TPB Ref.: A/YL-LFS/546

Temporary Open Storage of Construction Materials for a Period of 3 Years at Lots 1700 (Part) & 1701 (Part) in D.D. 129, Lau Fau Shan, Yuen Long, N.T.

Response to CEDD's comments (Planning Application No. A/YL-LFS/546) - 23 April 2025

Figure 5

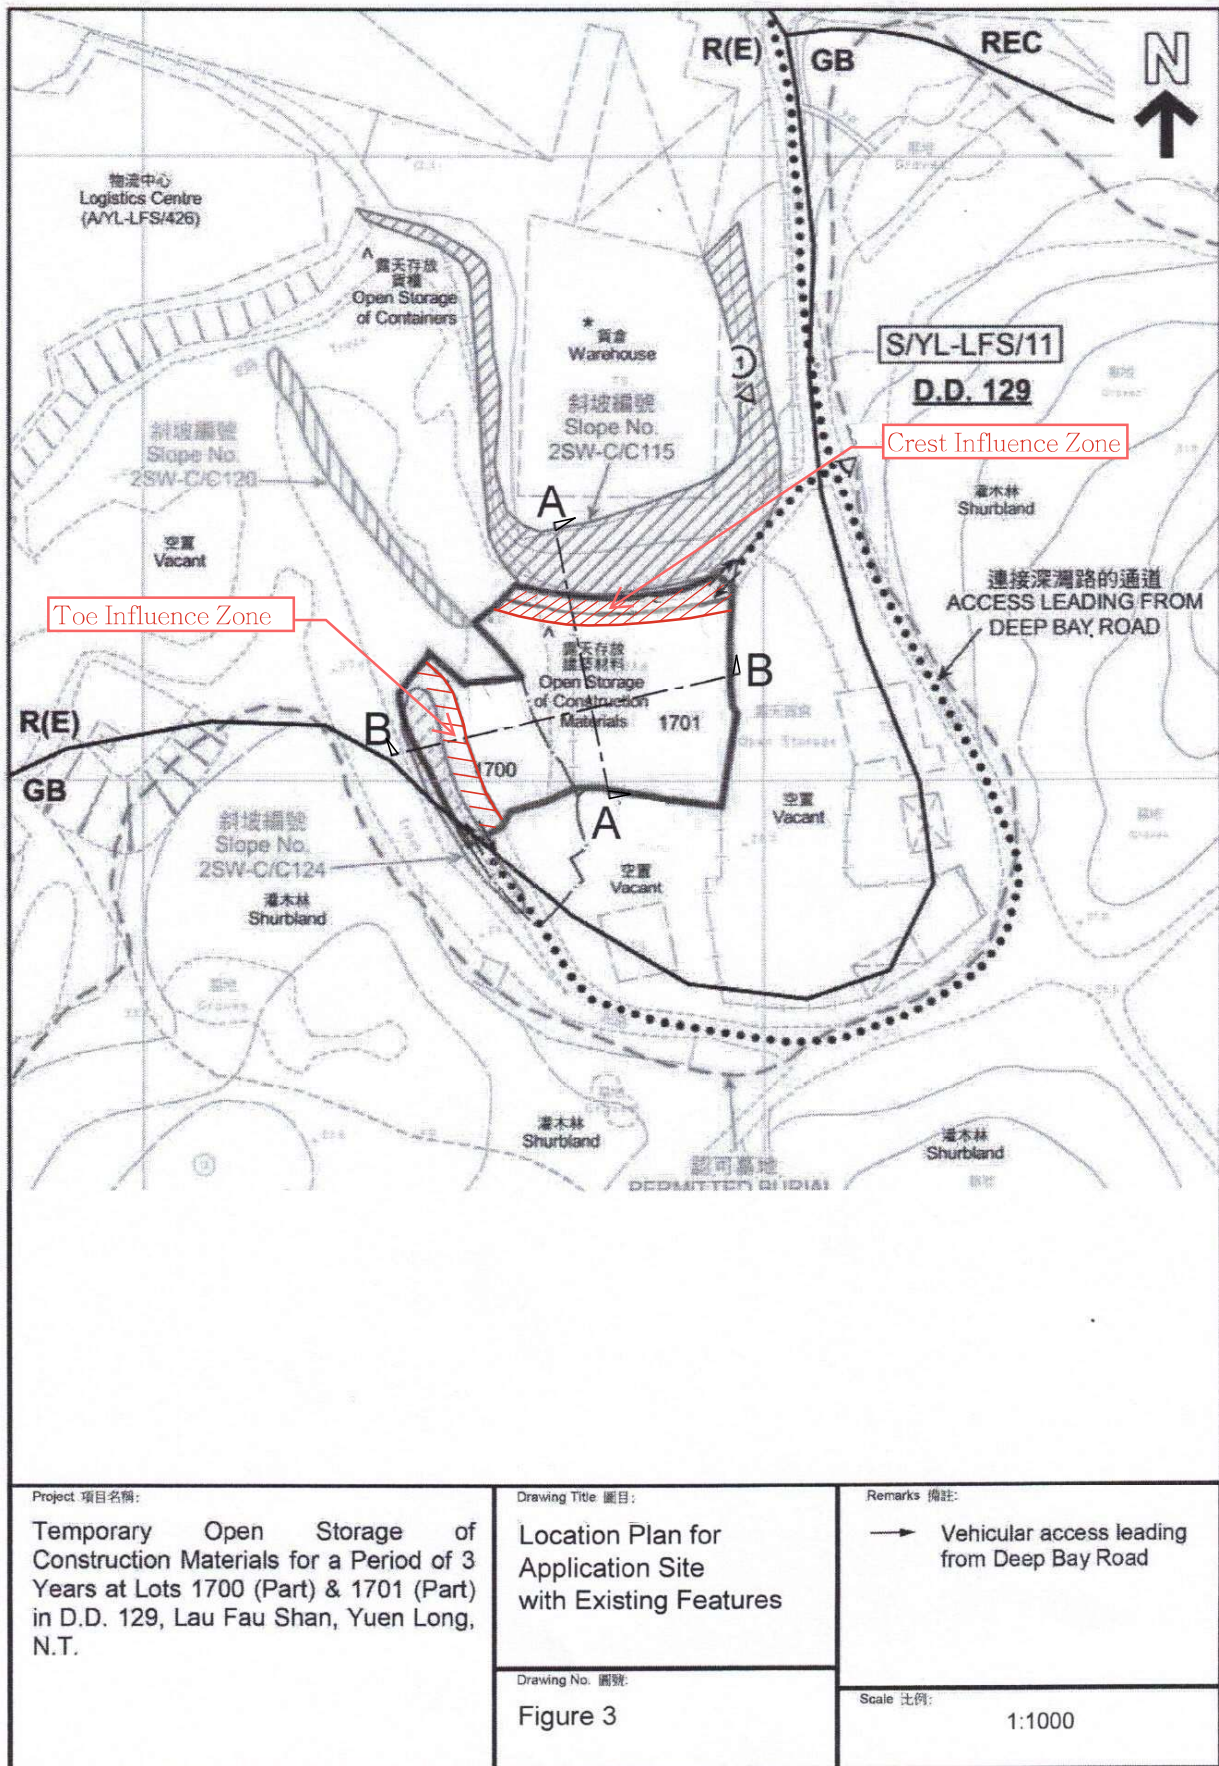
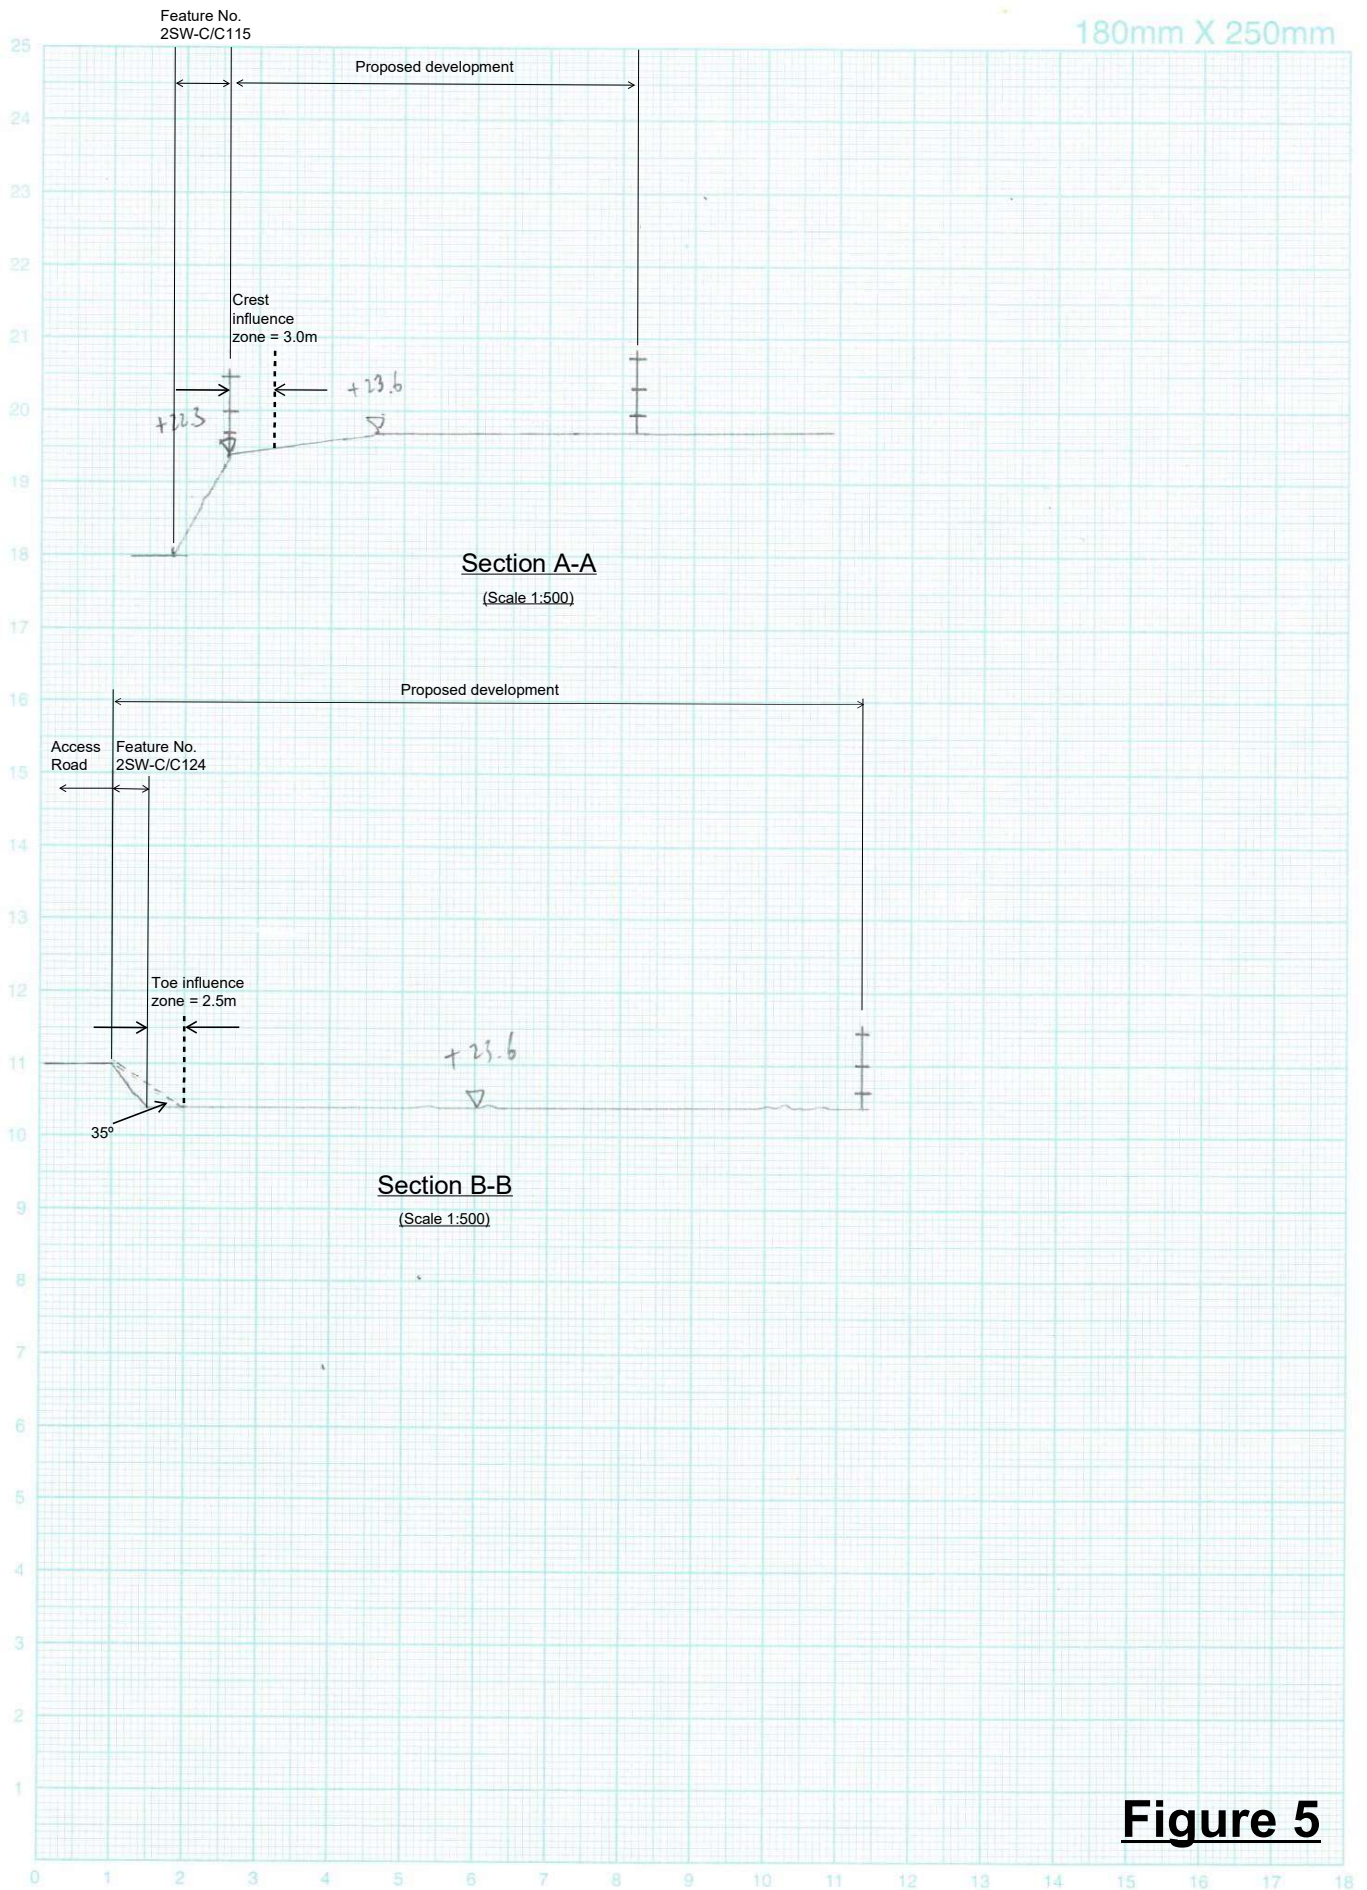
<p>2. In view of para. 2 above, relevant geotechnical cross-section showing the proposed development area and the feature concerned should be provided.</p>	<p>The cross sections are shown in the enclosed Figure 3 and 5.</p>
